El Camino Bike Lanes – Caltrans Questions

General Questions

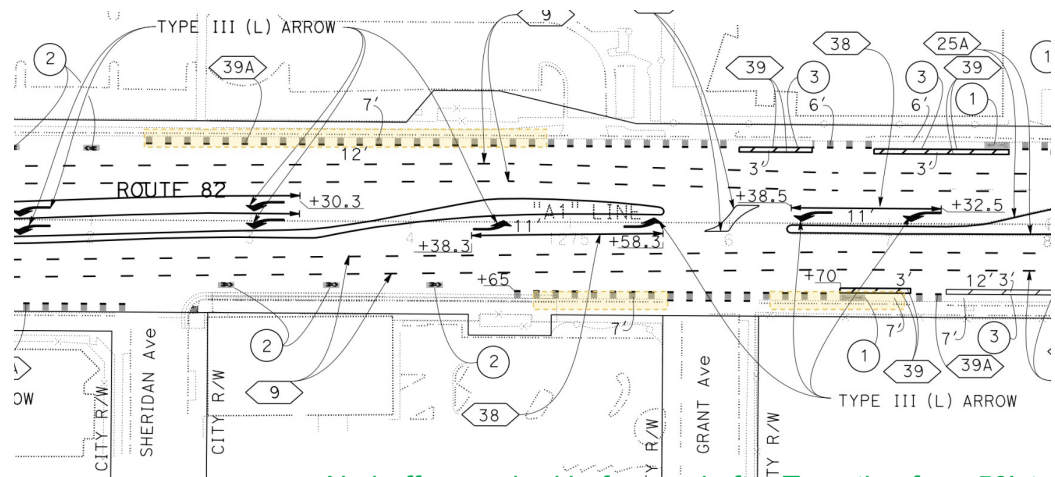
2. What are the exact guidelines for the width of bike lanes and protective buffers? Would it be feasible or sensible to convert 7' bike lanes without any protective buffer to a 5' bike lane with a 2' buffer?
 - a. There are several unprotected sections with a 7' bike lane, without other conflicts like bus stops and driveways. Presumably, these areas are unprotected because the right-of-way is too narrow to include a buffer. However, these unprotected 7' lanes could plausibly become a narrower bike lane with a 1.5' to 2' buffer. (To be clear, I'm not saying this is the right tradeoff – I'm just asking whether this is reasonable.)

- b. For example, see some highlighted sections near Sheridan and Grant, where a 7' bike lane abuts a 12' car lane. **At this location, bike lane width varies from 5 to 7 feet.**

No buffer required before and after T-section from 50' to 200'

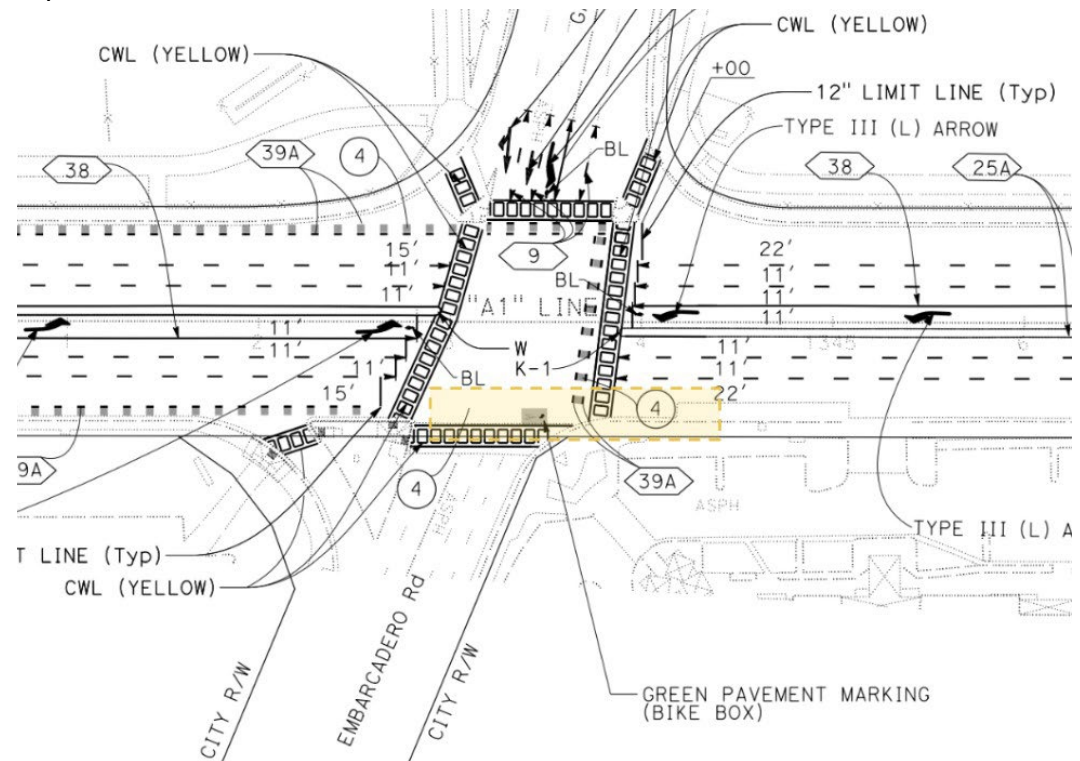
3. Can you confirm whether cars will be allowed to make a right-turn on red at bike boxes?
How does Caltrans determine which intersections get a bike box?
 - a. I'm trying to understand if it's reasonable to add more bike boxes, especially along [city recommended / safe school routes](#).

Bike boxes were picked for locations to either reduce turning collision (California Ave) or to act as a wayfinding to direct cyclists to turn (Embarcadero). This counter measures increases cyclists' visibility to motorists and to allow bicyclists to get ahead of queuing traffic during the red signal phase. Bike boxes can be used with a 'no turn on red' sign to clarify that the motorist cannot make a right turn on red.

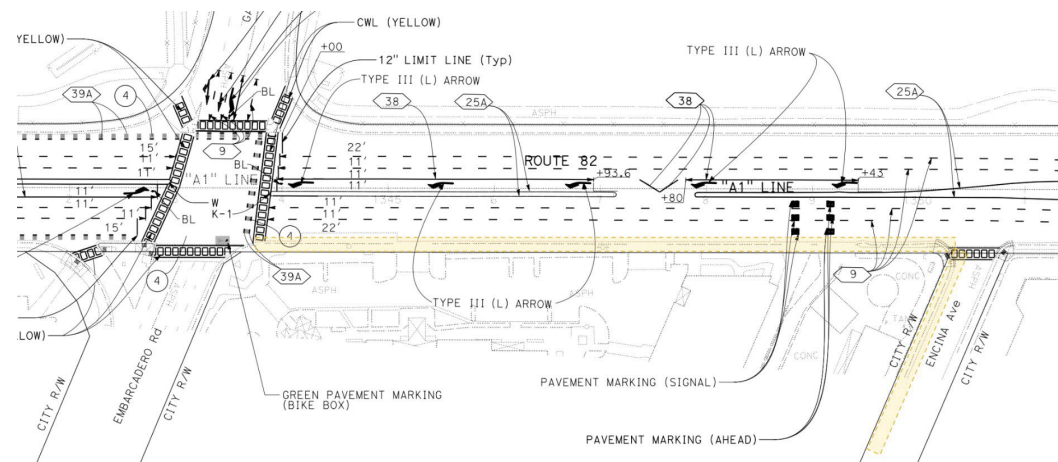
5. Did Caltrans consider extending the Northbound bike lane from Embarcadero to Encina Ave?

- a. See how the area seems sufficiently wide, with a ~22' right travel lane.

The route wasn't extended to Encina Ave, because the bikeway would have to end prior to University. The signalized intersection at Embarcadero offers a way for cyclists to transition to the Stanford Path.

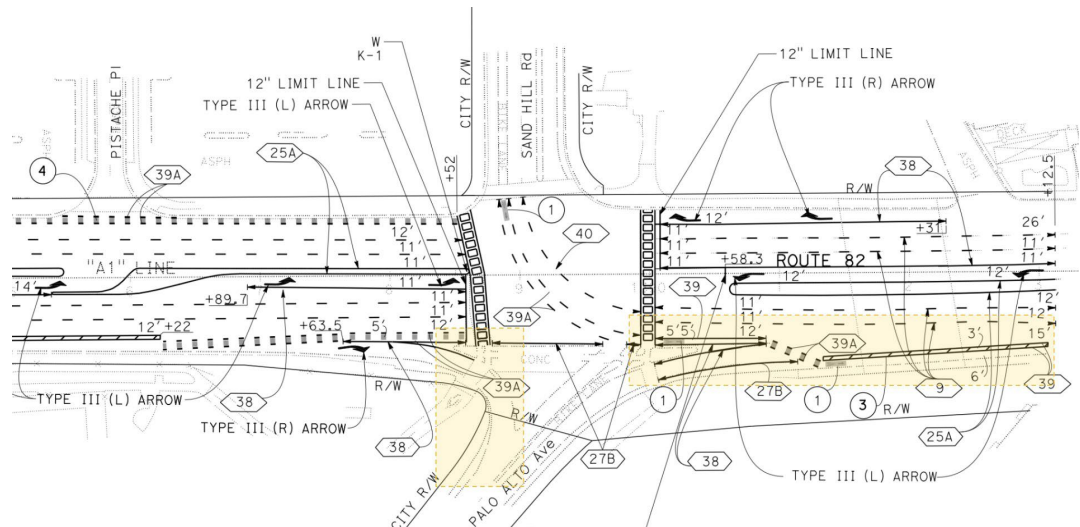
- b. By continuing to Encina Ave, there's a more natural way for cyclists to reach Caltrain, Palo Alto Medical Foundation, Town and Country, and the Embarcadero Bike Path.

There are positives and negatives about continuing the bikeway to Encina Ave. While it does provide more connections to the Embarcadero Bike Path, Churchill and Embarcadero Rd both have connections to the Embarcadero Bike Path as well. The design didn't want to encourage cyclists to proceed northbound on El Camino after

Embarcadero Rd. The bike box has a left arrow pointing cyclists toward the Stanford Path.

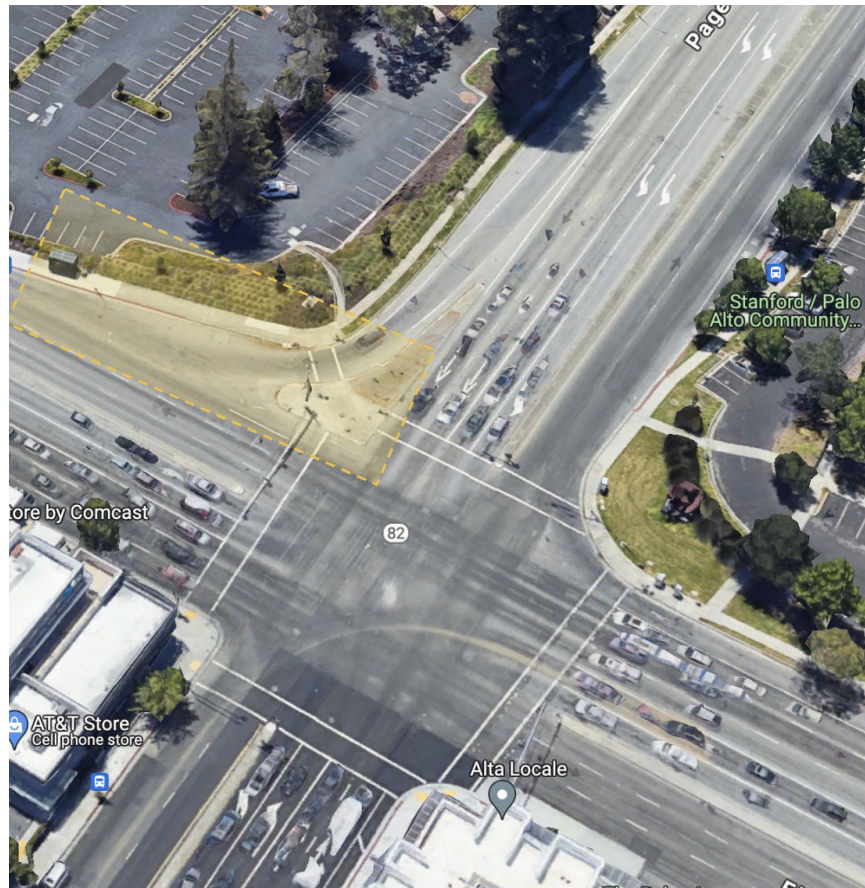
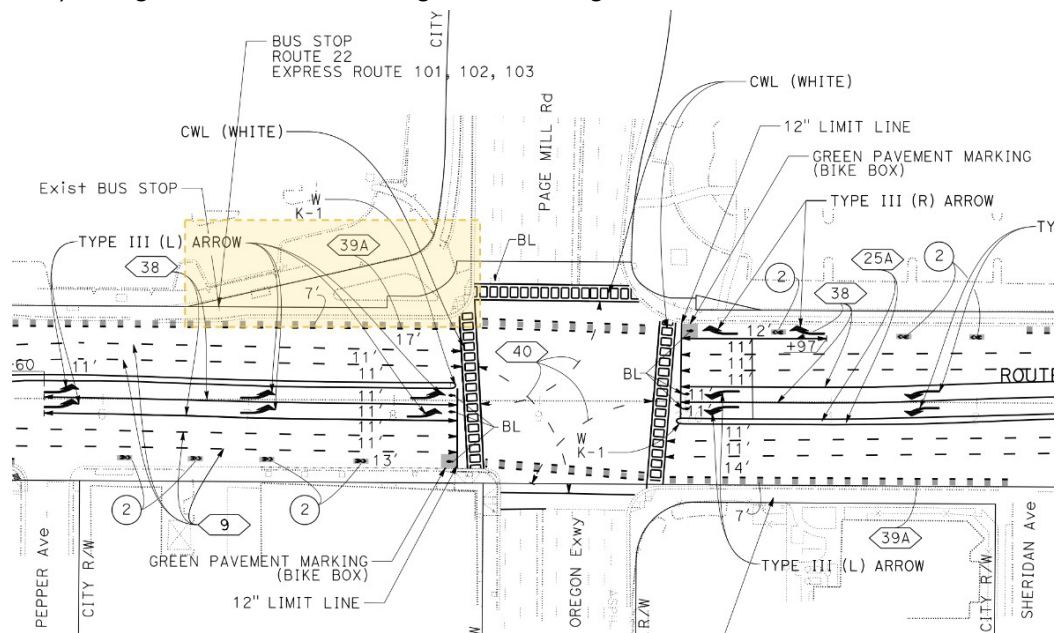
7. Have there been attempts to limit fast turns onto El Camino? More specifically, is there any communication with the county about Page Mill Road? The County informed the future project to improve this intersection and plan to begin after the Caltrans paving project is completed. The draft plan shows extending the corner sidewalk and removing the right turn lane at the porkchop island.
 - a. For example, the highlighted section of Page Mill includes a porkchop / pedestrian island. Cars drive through that channel extremely quickly, and sight angles are awkward. It seems likely that the bike lane will be used as an extremely dangerous merging lane for cars. Ideally we can coordinate with the county to eliminate the porkchop (or at least add signs, lighting, more green paint, etc.).

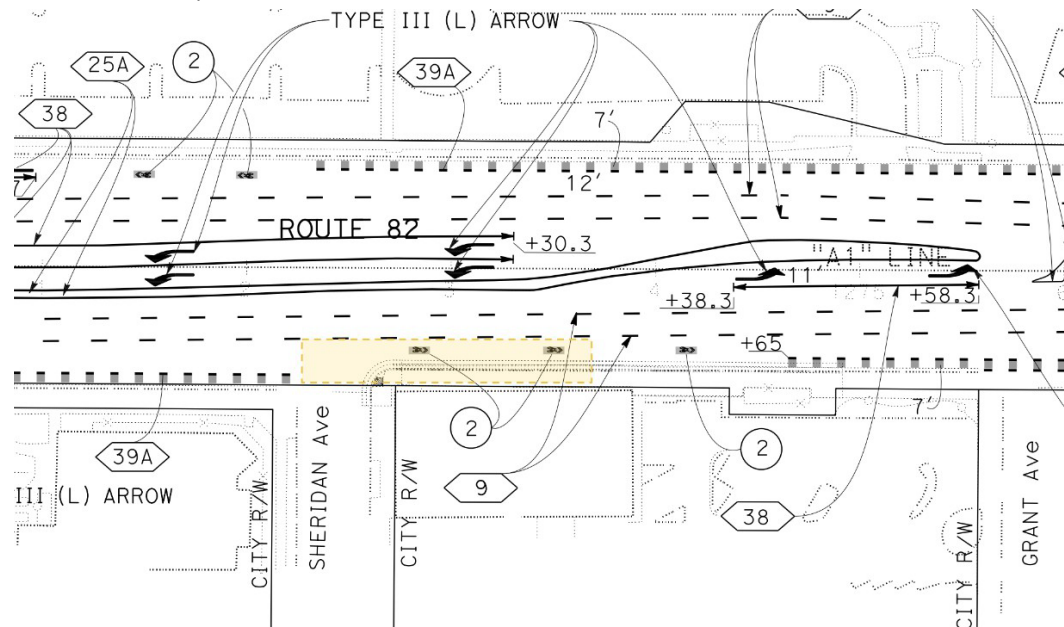
8. At locations where protected bike lanes abruptly end, will there be signs to warn cyclists and drivers? What will the signs say?

- a. See intersection at Sheridan. Inexperienced cyclists may panic if they suddenly realize they're sharing a car lane. (Similar conditions exist at Embarcadero, Churchill, etc..)

Sharrow markings are used to warn cyclists that a bike lane is ending.
